Subject: Duke Energy Corporation
Oconee Nuclear Station - Units 1, 2, and 3
Docket Nos. 50-269, 50-270, and 50-287

Revisions to Topical Report DPC-NE-3003 In Support of
Steam Generator Replacement
Response to NRC Staff Request for Additional
Information

Duke Power Response To Request For Additional Information

DPC-NE-3003 Revision 1 “Mass and Energy Release and Containment Response Methodology”

GOTHIC 7.0 - FATHOMS COMPARISON
ROTSG LARGE BREAK LOCA
(14.1 ft² Break - SG Inlet - High Initial RCS Flow w/ 5° ΔTcold Loop Case 1)

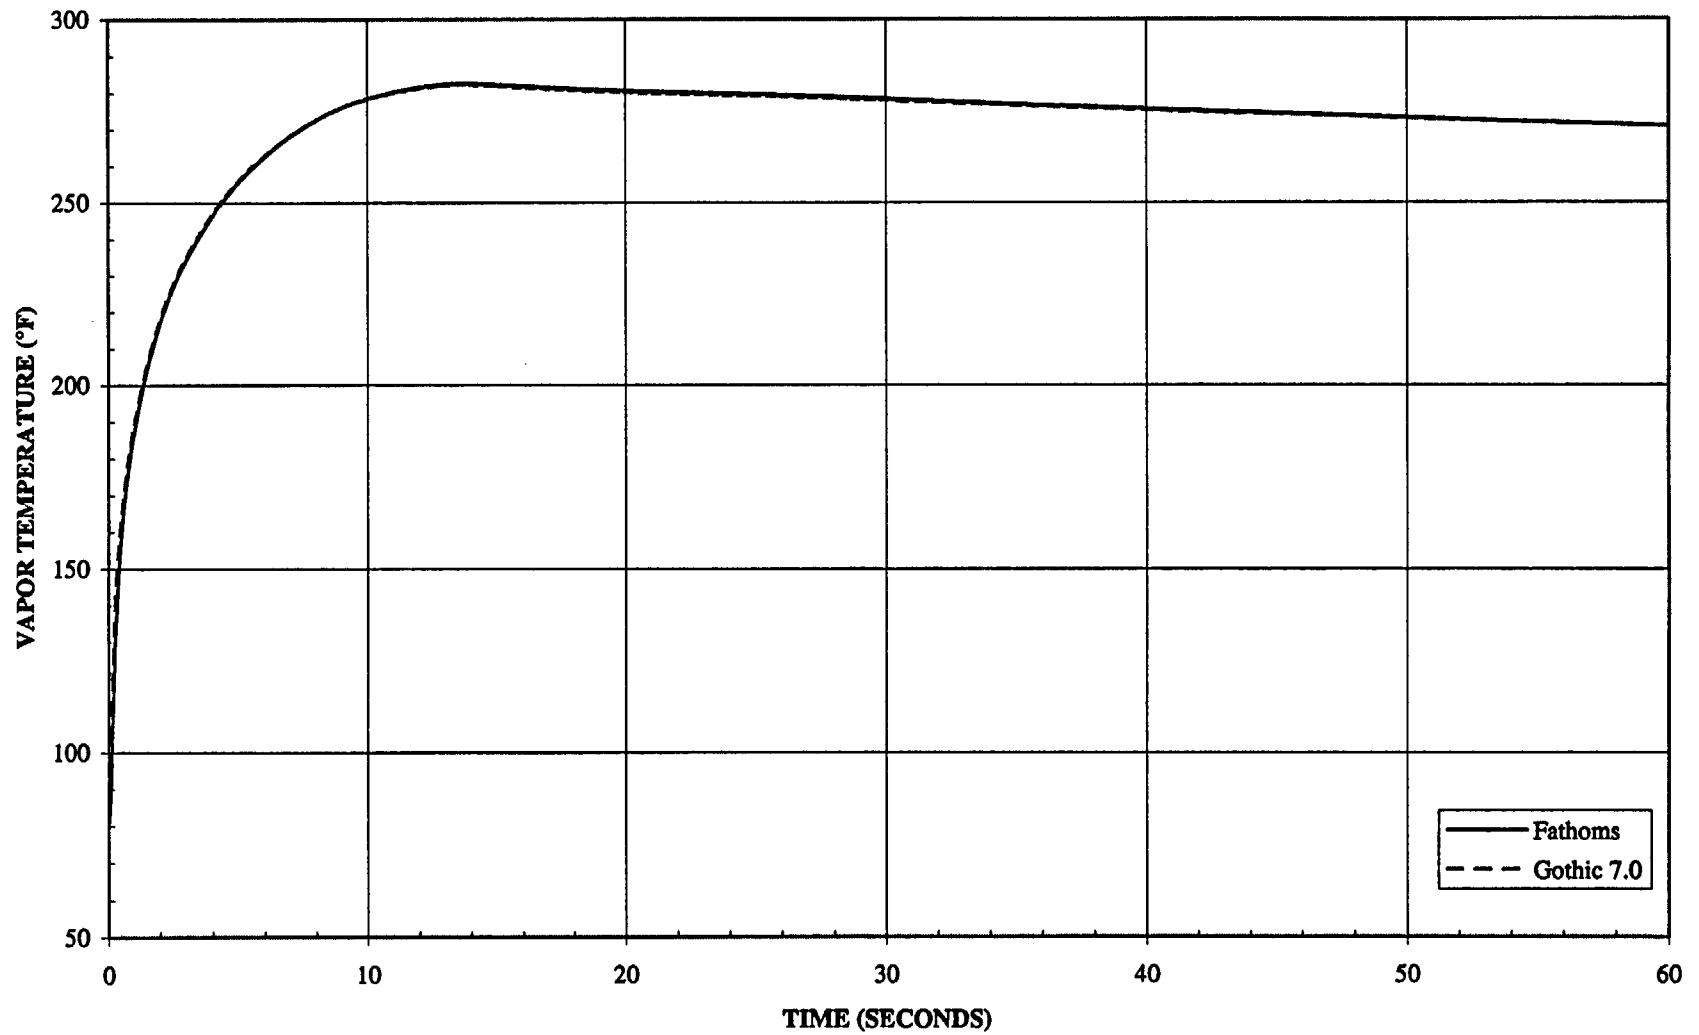
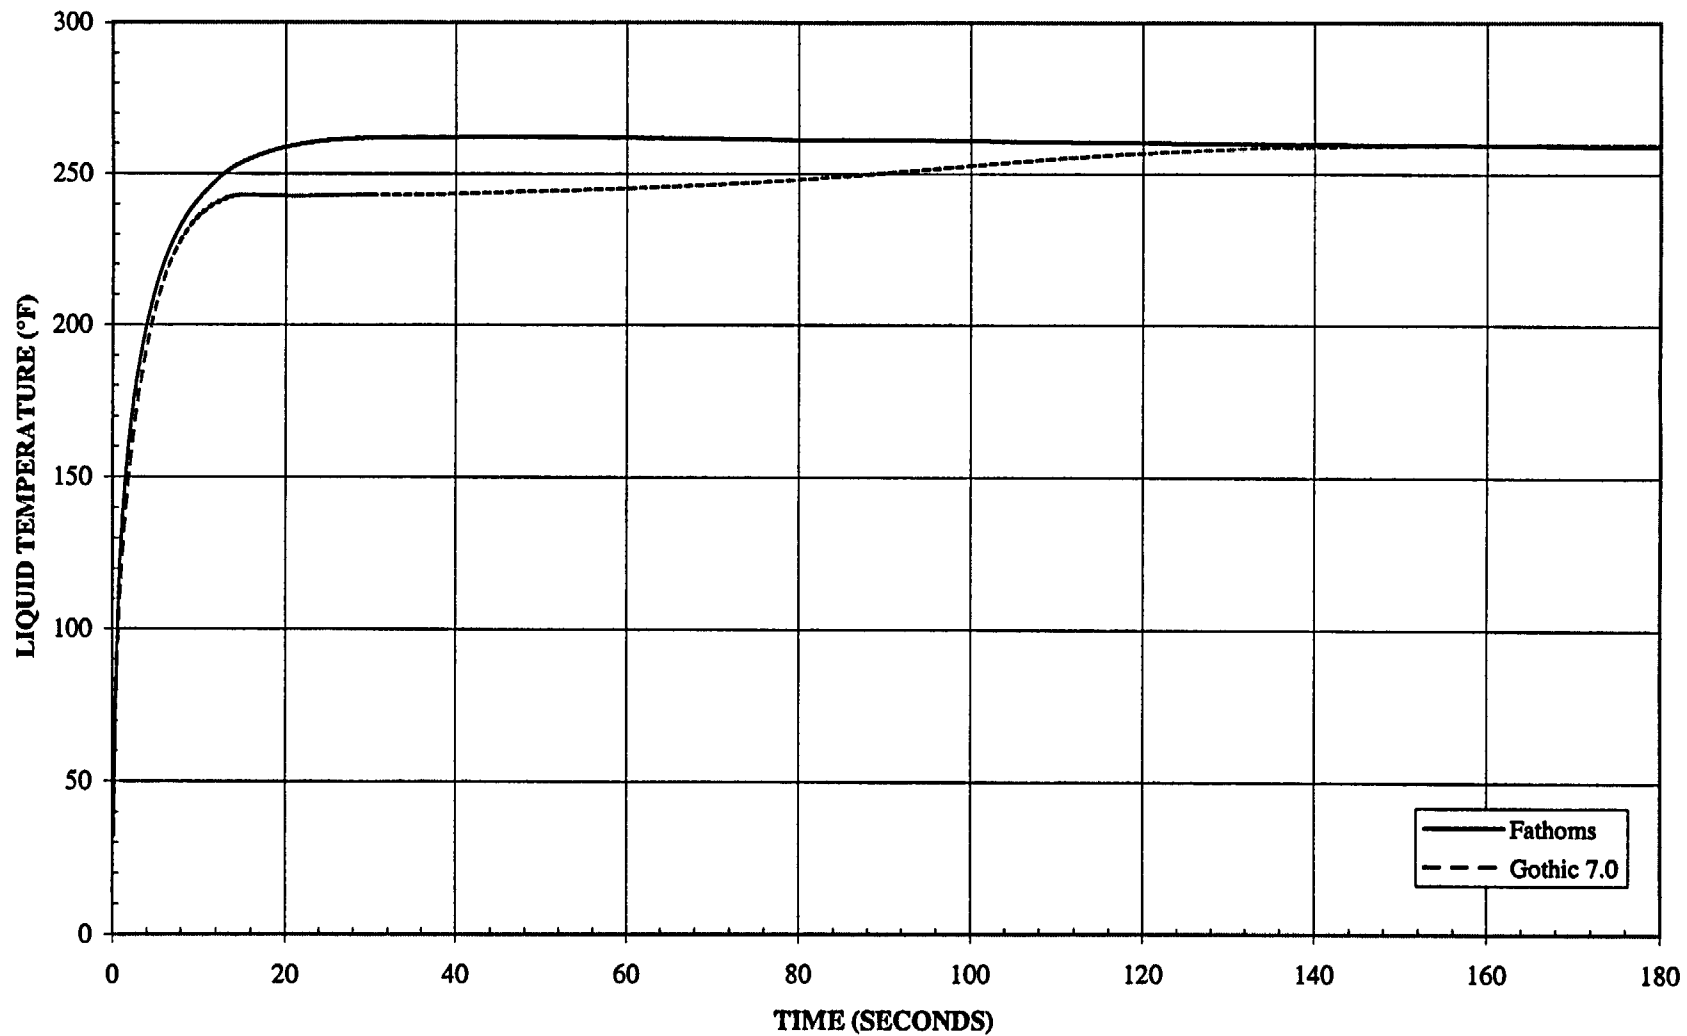
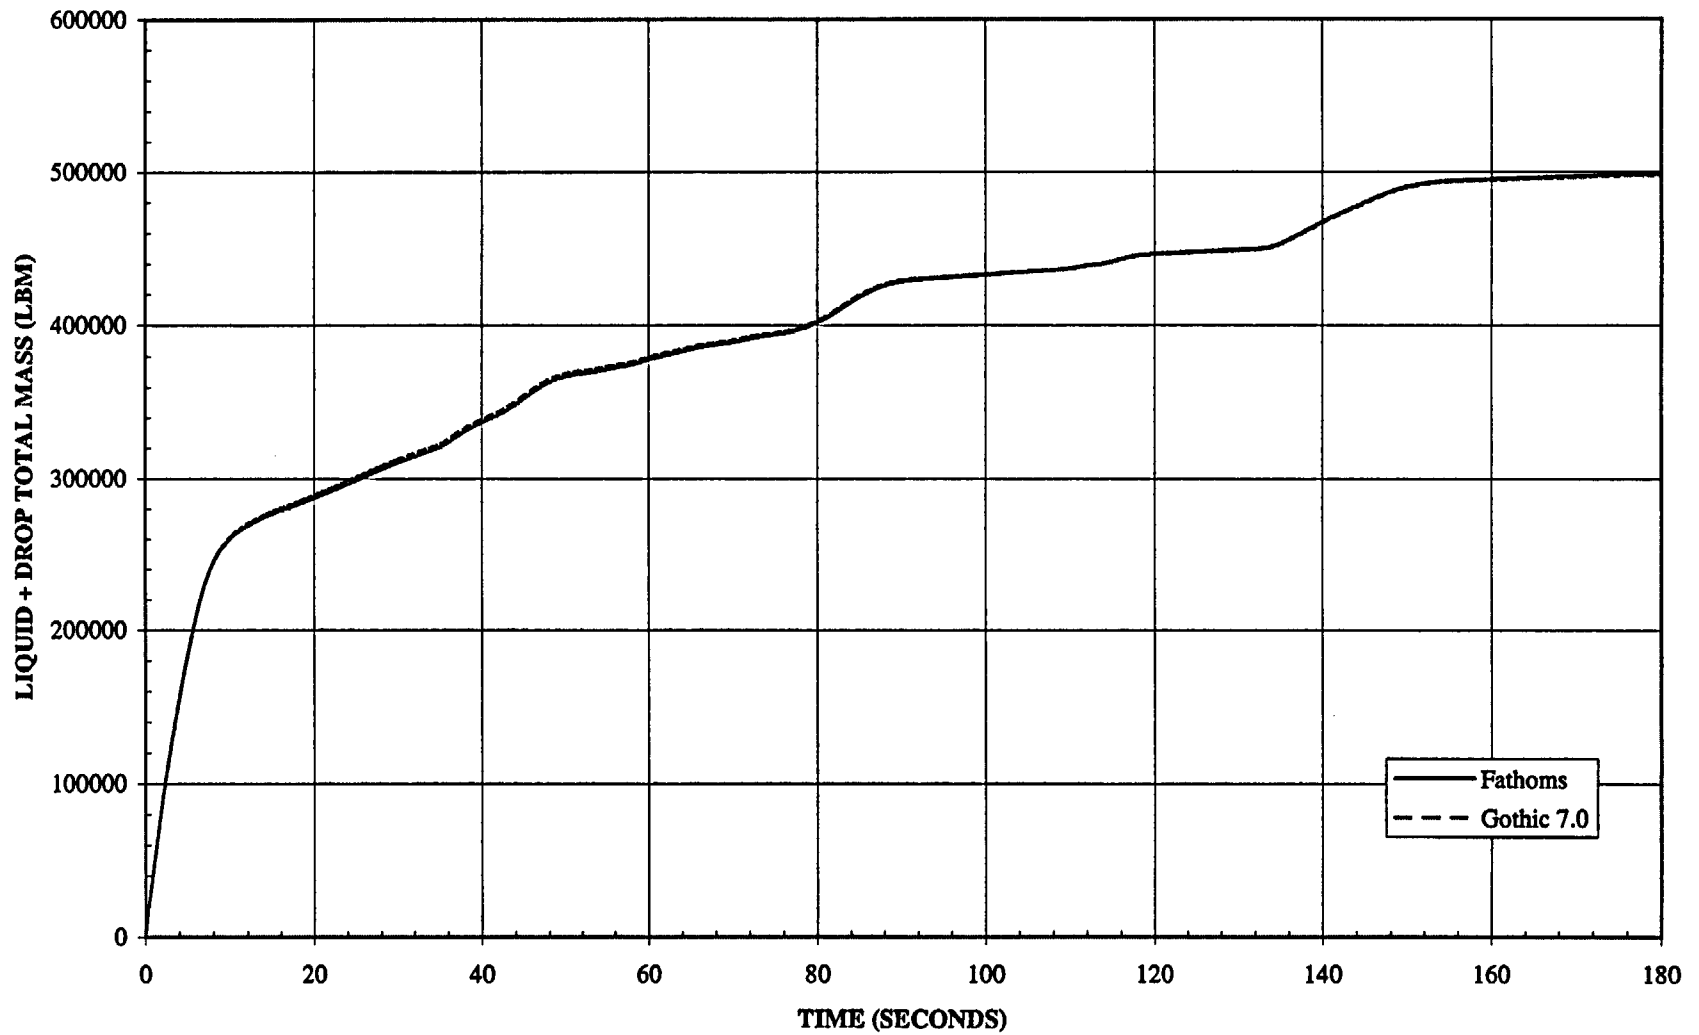
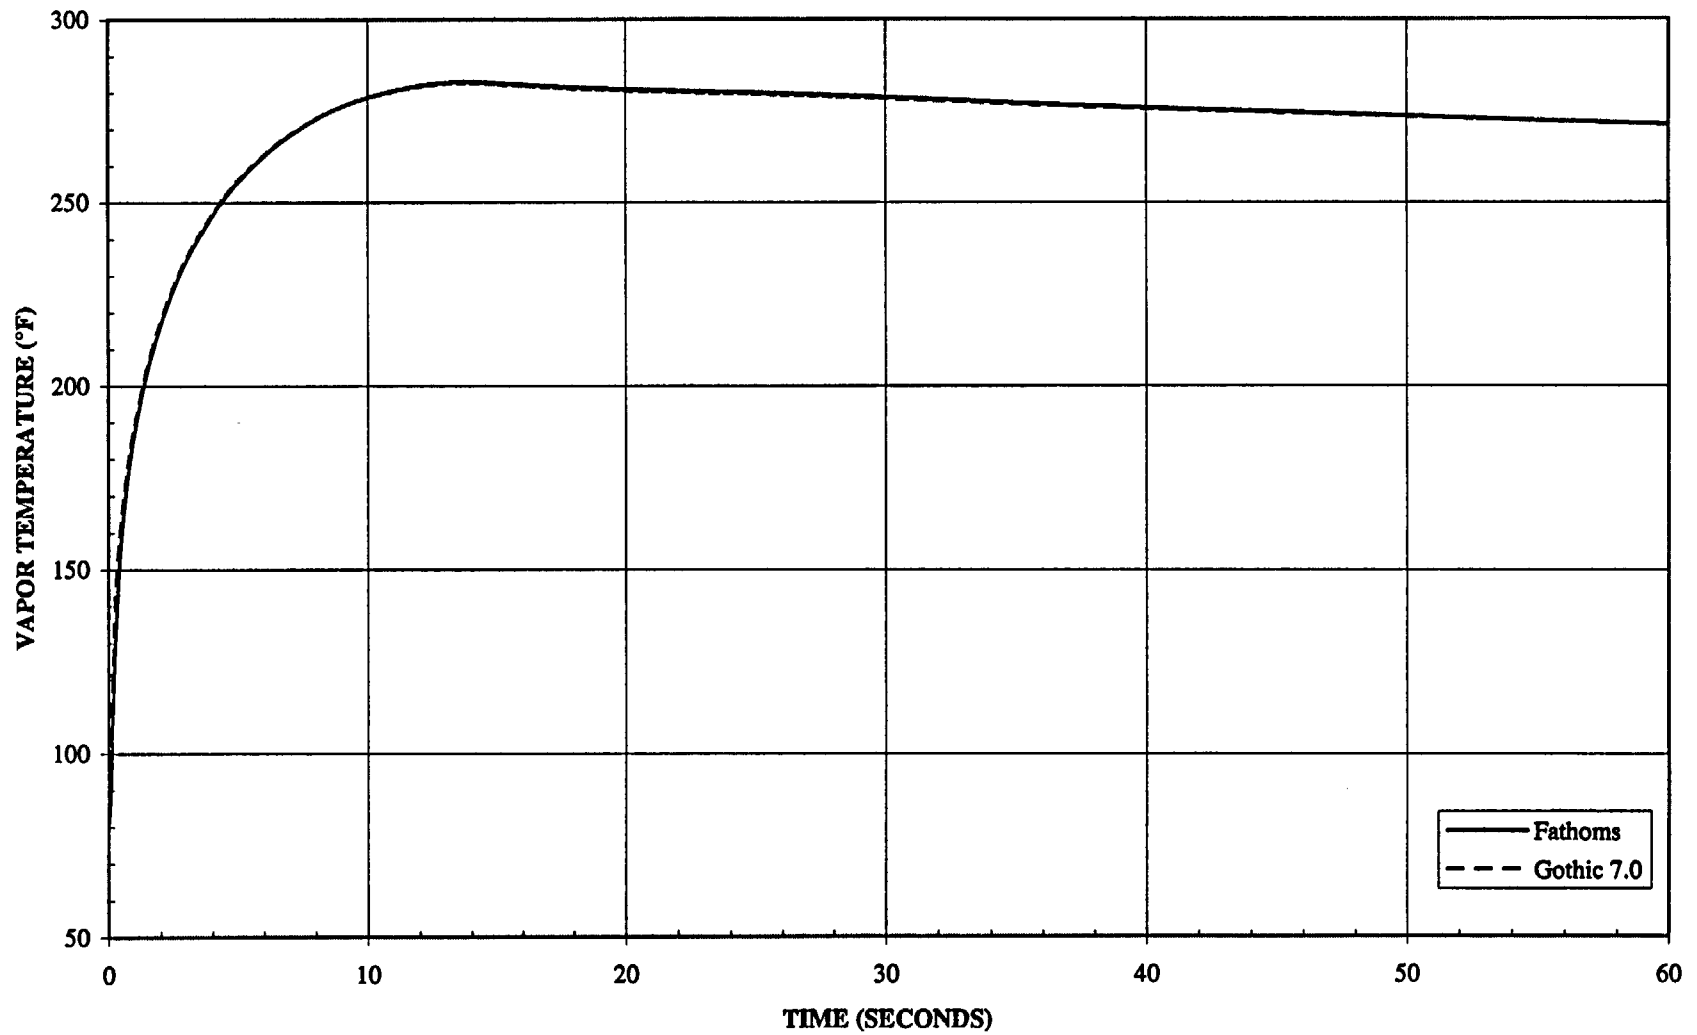
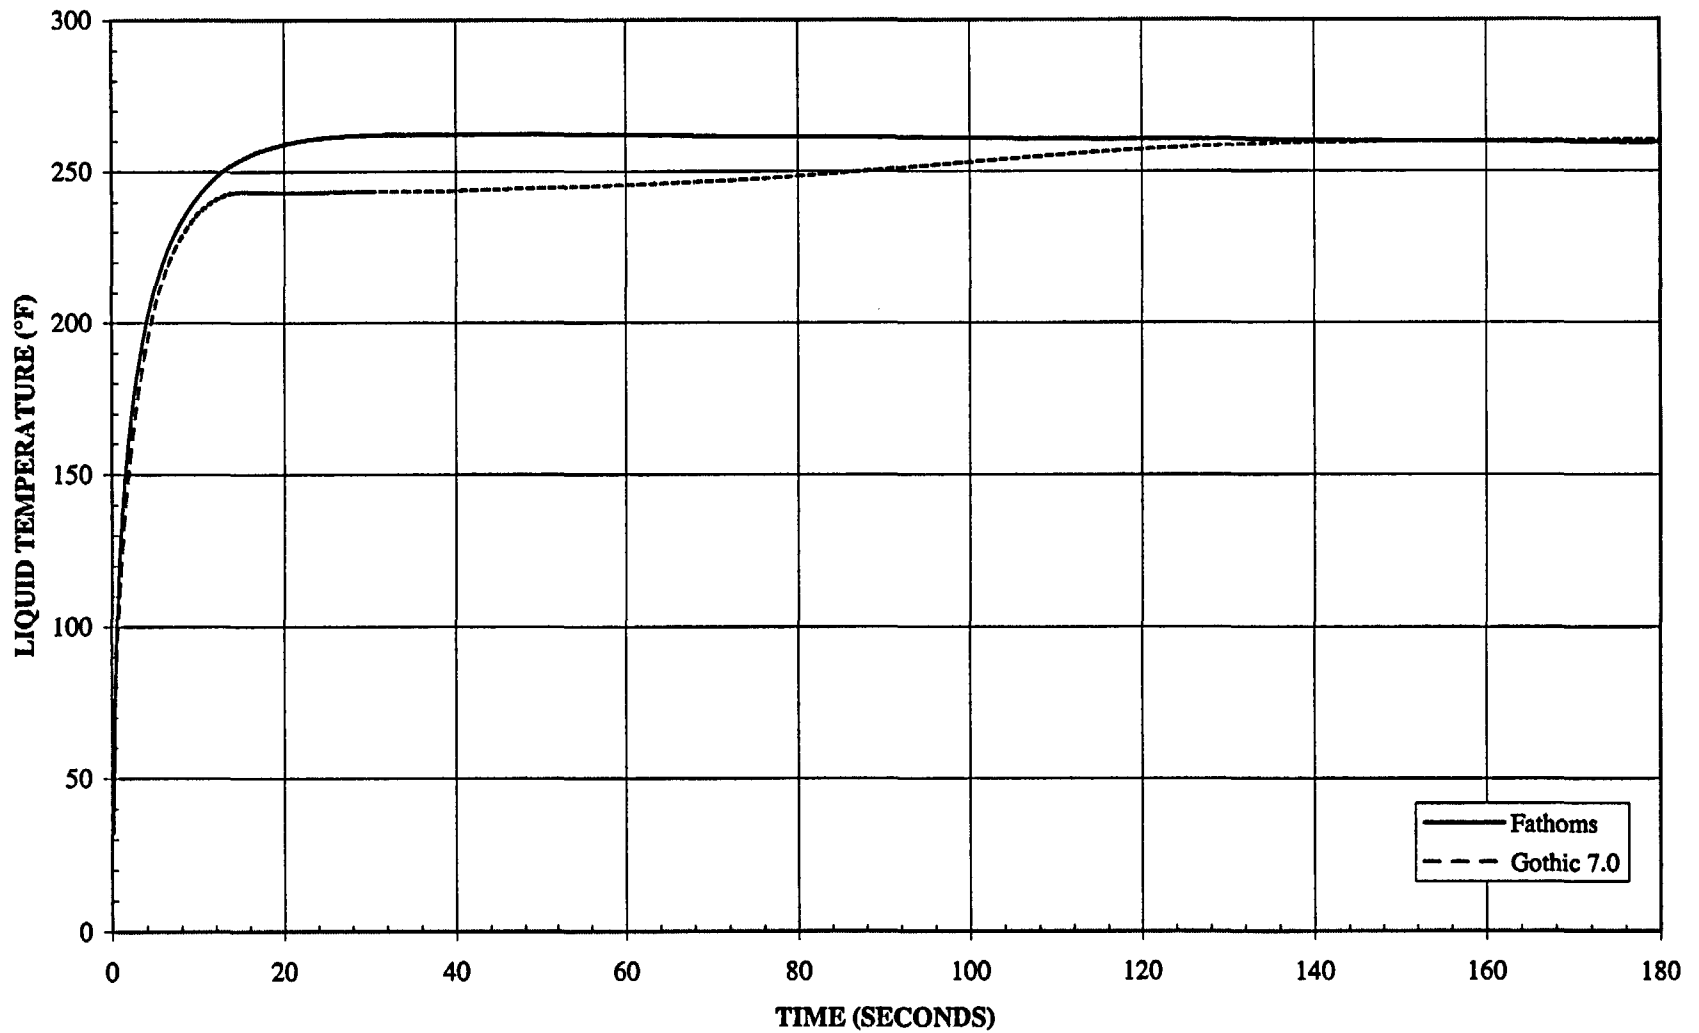
3. Please provide the results using the GOTHIC 7.0 code of peak pressure and temperature calculations for the sensitivity cases listed in Table 3.1-1 of DPC-NE-3003 in tabular and graphical form. If the results or conclusions are significantly different from those presented in DPC-NE-3003P, explain the difference.

Response: Table 3.1-1 of DPC-NE-3003 describes a spectrum of LOCA peak pressure cases including a range of break locations and sensitivity analyses for several important modeling assumptions. The staff's request is understood to focus on the difference in the predicted results from the FATHOMS and GOTHIC 7.0 code versions. Rather than show the comparison for the cases in Table 3.1-1, a different set of cases has been selected which is more focused on the current knowledge of the key sensitivity parameters. Also, the results presented are for the ROTSGs, which is the subject of Revision 1 to the topical report.

The results of the 14 code comparison analyses are shown in Table 3-1 below and in the figures that follow. In general, the pressure and vapor temperature response predictions were very similar in both magnitude and trend. GOTHIC 7.0 predictions for peak pressures and vapor temperature were slightly lower (~0.5 psig and 0.5°F). These differences are consistent with the code model differences described in the response to Question #1. Both codes predict a saturated containment atmosphere due to the large amount of drops injected. The slightly lower pressure, vapor temperature, and liquid temperature from GOTHIC 7.0 may be attributed to additional drop hold up in the atmosphere. This effectively increases the heat capacity of the atmosphere and reduces the temperature rise for a given energy addition. A comparison of the total liquid and drop masses, and liquid temperatures, show the predictions of the two codes to be essentially the same. This is consistent with the changes in the drop deposition and entrainment models discussed in Question #1. These results show that the two code versions give essentially similar results for the same break location and initial and boundary conditions.
